Access Compliance Report

Public Rights-of-Way

(Curb Ramps)

Intersection ID: 8684	Main Street: CENTRE_ST	Cross Street: DARBY_AV	Location: S
ADA ID: 60F6421F914D	Ramp Type: Perp	Initial Pass/Fail: Fail	Overall Compliance: No
		Severity Score: 10

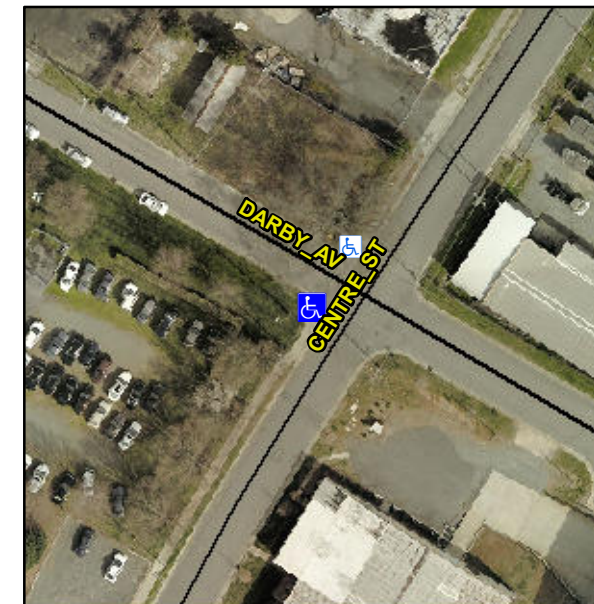
Not Found, R304.5.1, R304.5.3

Compliance	Description	Data	Compliance	Description	Data
N/A	Ramp Length (in)	74.0	Yes	Ramp Slope (%)	6.6
No	Ramp Width (in)	47.5	No	Ramp XSlope (%)	4.9
N/A	Flare Type LT	N/A	N/A	Flare Type RT	N/A
N/A	Flare Slope LT (%)	N/A	N/A	Flare Slope RT (%)	N/A
N/A	Flare Traversable LT?	N/A	N/A	Flare Traversable RT?	N/A
N/A	Landing Length (in)	N/A	N/A	DWS Provided?	N/A
N/A	Landing Width (in)	N/A	N/A	DWS Contrast?	N/A
N/A	Landing Slope (%)	N/A	N/A	DWS Length (in)	N/A
N/A	Landing X Slope (%)	N/A	N/A	DWS Full Width?	N/A
N/A	Landing Curb? (Y/N)	N/A	N/A	DWS Offset (in)	N/A
N/A	Shared Landing?	N/A			
N/A	Gutter Ponding?	N/A	N/A	Gutter Slope (%)	N/A
N/A	Gutter Lip Ht (in)	N/A	N/A	Gutter X Slope (%)	N/A
N/A	Painted X Walk1?	No	N/A	Painted X Walk2?	N/A
	X Walk 1 Direction	To NE		X Walk 2 Direction	N/A
N/A	X Walk 1 Width (in)	N/A	N/A	X Walk 2 Width (in)	N/A
	X Walk 1 Slope (%)	4.8		X Walk 2 Slope (%)	N/A
	X Walk 1 X Slope (%)	1.7		X Walk 2 X Slope (%)	N/A

Remove & Replace Entire Ramp.
